PLAN COMMISSION AGENDA

October 14, 2026
1:00 PM
Village Hall, Room B114 Ebe Auditorium
8811 Campus Drive, Mount Pleasant, WI 53406

1. **13231 Louis Sorenson Road Certified Survey Map; CSM-26-07**
   CERTIFIED SURVEY MAP
   UTILITY EXHIBIT
   ALTA SURVEY
2. **12023 Durand Avenue Site Plan Review; SP-26-11**
   APPLICANT NARRATIVE
   SURVEY
   SITE PLANS
   ARCHITECTURAL PLANS
   SEWER AND WATER SERVICE PLANS
   LANDSCAPE AND SCREENING PLANS
3. **Green Bay Road S Certified Survey Map; CSM-26-08**
   CERTIFIED SURVEY MAP
4. **Fiona Fields Preliminary Plat; SPP26-0002**
   APPLICANT NARRATIVE
   PRELIMINARY PLAT
   ALTA SURVEY
   SOIL BORINGS AND TESTS

Plan Commission Meeting of October 14, 2026

Date: October 1, 2026
Survey No. 4404.10B
Sheet 4 of 23

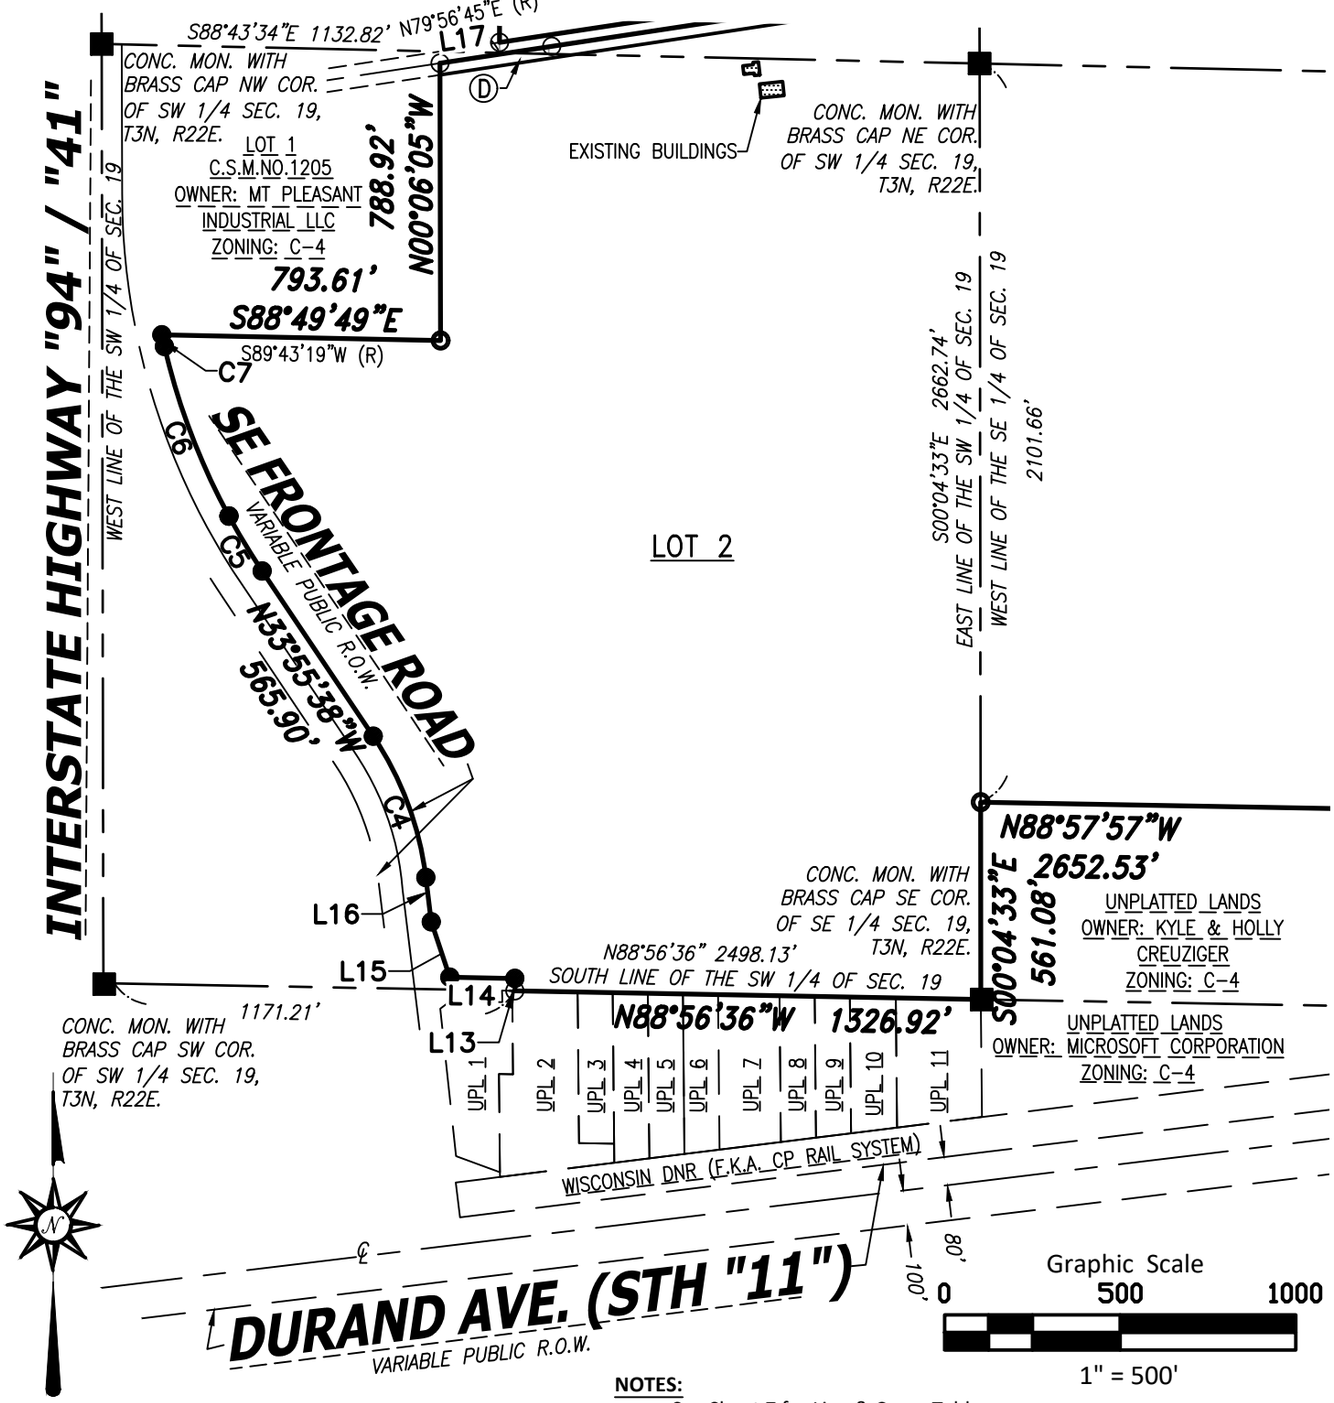
4	The § 74-7.3 restriction note is attached to no delineated area.	Delete the note.
4	Legend defines F.K.A. as "Formally Known As."	Should read "Formerly Known As."
21	Surveyor's certificate still refers to the "Village of Mt. Pleasant Land Division Ordinance" while every caption now reads Mount Pleasant.	Conform.
All	Title block gives the firm's address as Milwaukee, WI 53204 on all 23 sheets; all five sheets of the Area North Utilities exhibit, Drawing 4404.00, give 53203 for the same address.	53203 is correct for 710 N. Plankinton Ave. Correct the CSM.

- See Sheet 7 for Line & Curve Tables
- Per Chapter 74-7.3 of the Village of Mount Pleasant Code: This area is reserved for the planting of trees an shrubs. Pedestrian, bicycle, and other recreation trail facilities and access may be allowed. No motor vehicle access shall be permitted across this area, except those for personal assistance mobility devices for individuals with mobility disabilities. The building of structures, expect fences or walls for screening or buffering purposes and public or private utility structures, is prohibited hereon.

1. Show the 80-foot Nations Drive right-of-way along the north line of Lot 1 as designated in the Comprehensive Plan, dimensioned with its length and area, and dedicate or reserve it as the Village directs under § 74-2.5(a).
2. Add the mortgagee's certificate or a title-supported note that no mortgages of record encumber the land.
3. Revise the Village Board block to approve the dedication of Louis Sorenson Road expressly, and have the approving resolution recite acceptance.
4. Cite the instrument vacating Louis Sorenson Road or remove the note.
5. Label the area of the 150-foot Hoods Creek reservation as § 74-6.2(i) requires.
6. Correct the scrivener's errors and the easement numbering errors identified in this report, and delete the § 74-7.3 restriction note from Sheet 4.

Date: October 1, 2026
Survey No. 4404.10B
Sheet 11 of 23

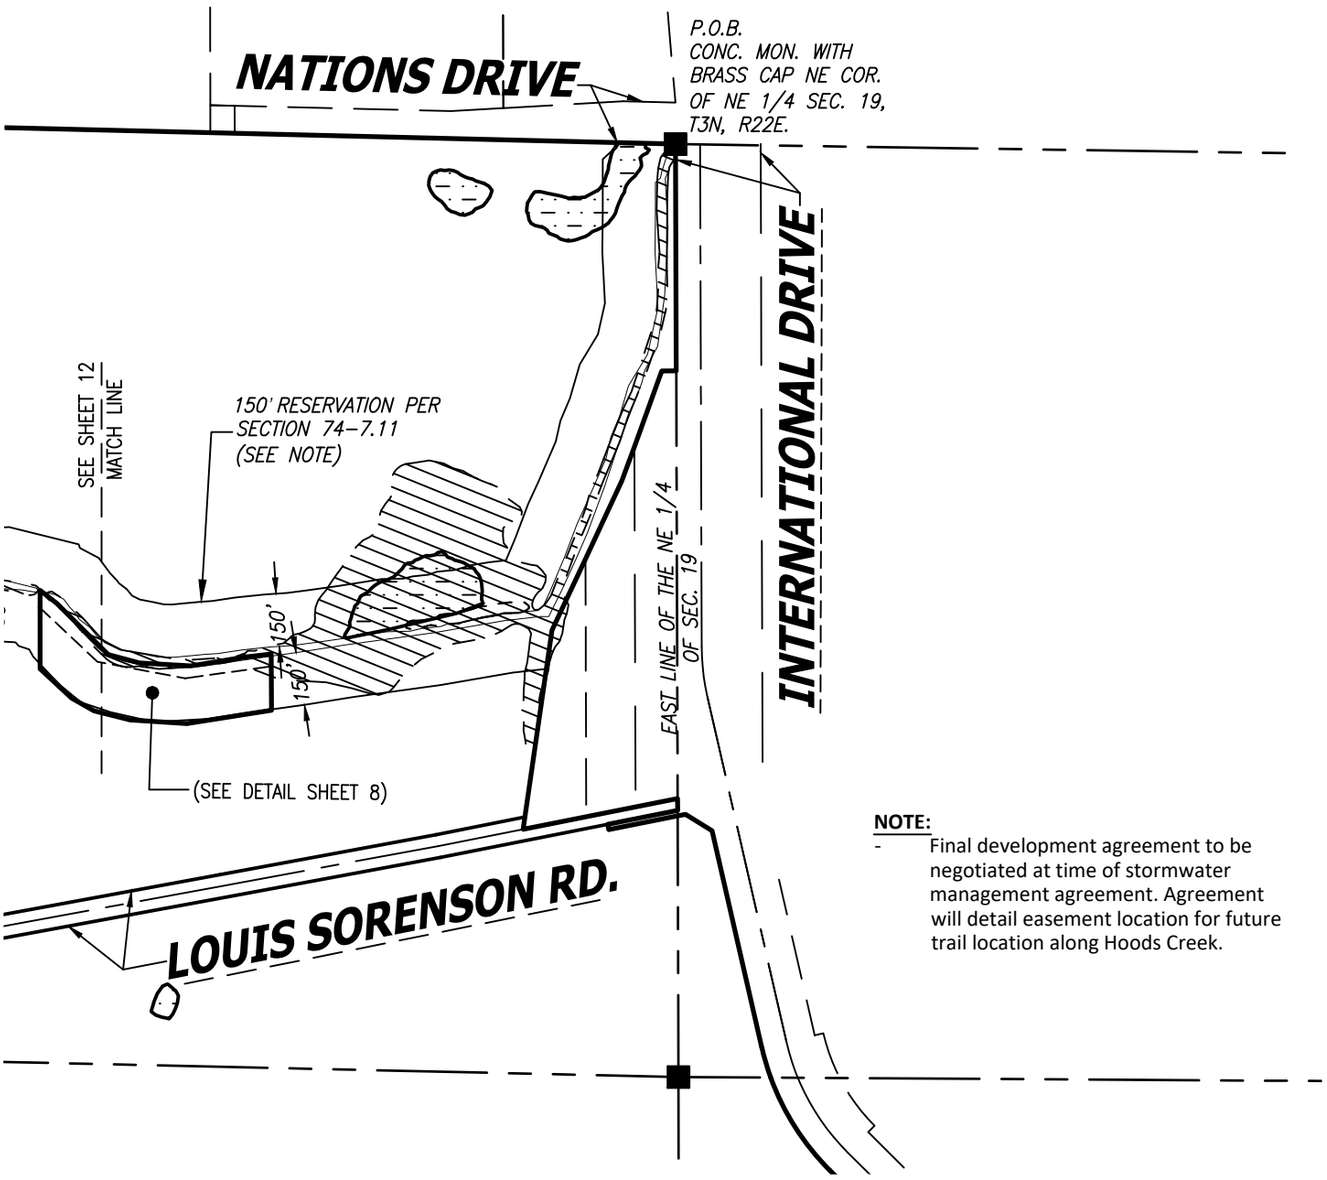
Park and open space, § 74-7.11. The map shows a 150-foot reservation along Hoods Creek on Sheets 11 through 13, labeled as being made under § 74-7.11, with a note that a final development agreement will be negotiated at the time of the stormwater management agreement and will detail the easement location for a future trail. Staff supports the reservation concept, as a reservation is Option 2 under § 74-7.11(a)(2). The Plan Commission must select the option and record that selection in the minutes. Section 74-6.2(i) requires the area of any reserved site. The 150-foot strip is dimensioned but carries no square footage or acreage.

- Final development agreement to be negotiated at time of stormwater management agreement. Agreement will detail easement location for future trail location along Hoods Creek.

Date: October 1, 2026
Survey No. 4404.10B
Sheet 12 of 23

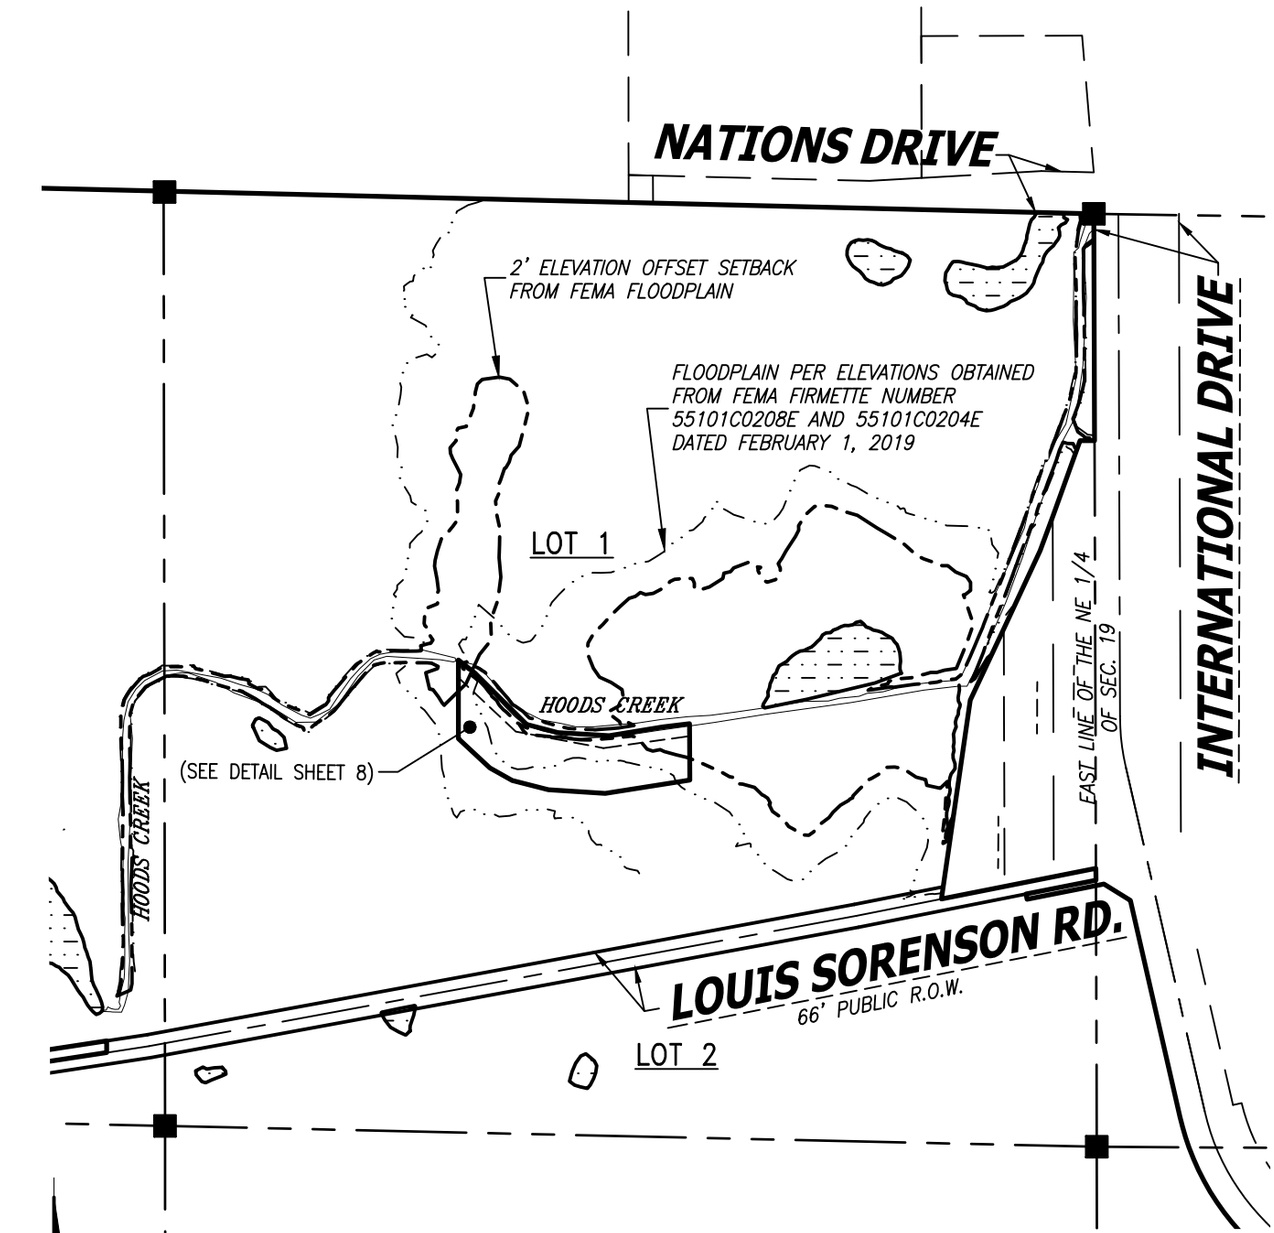
Sheet	Issue	Correction
14 and 15	Easement 1 cites Doc. Nos. 1176977, 1411770, and 2499317, while easement 4 separately cites 2499317. The ALTAs confirm 2499316 and 2499317 are different instruments, and 2499316 appears nowhere on the map.	Cite Doc. No. 2499316 in easement 1.
18 and 19	Two different easements are both numbered 16: the stormwater drainage easement per Doc. No. 2436103 on Sheet 18, and the 10-foot WEPCO easement per Doc. No. 1458779 on Sheet 19. Doc. No. 1458779 also appears as easement 12 on Sheet 18.	Renumber so each easement carries one unique number across the set.
2	The sheet index reads "Sheets 9 through 12 wetlands, environmental corridor and floodplain" and "Sheets 13 through 16 easements." The resource sheets actually run 9 through 13 and the easement sheets 14 through 19.	Correct the ranges.
12	The match line is labeled "SEE SHEET 12" on Sheet 12 itself.	Point it at the adjoining sheet.
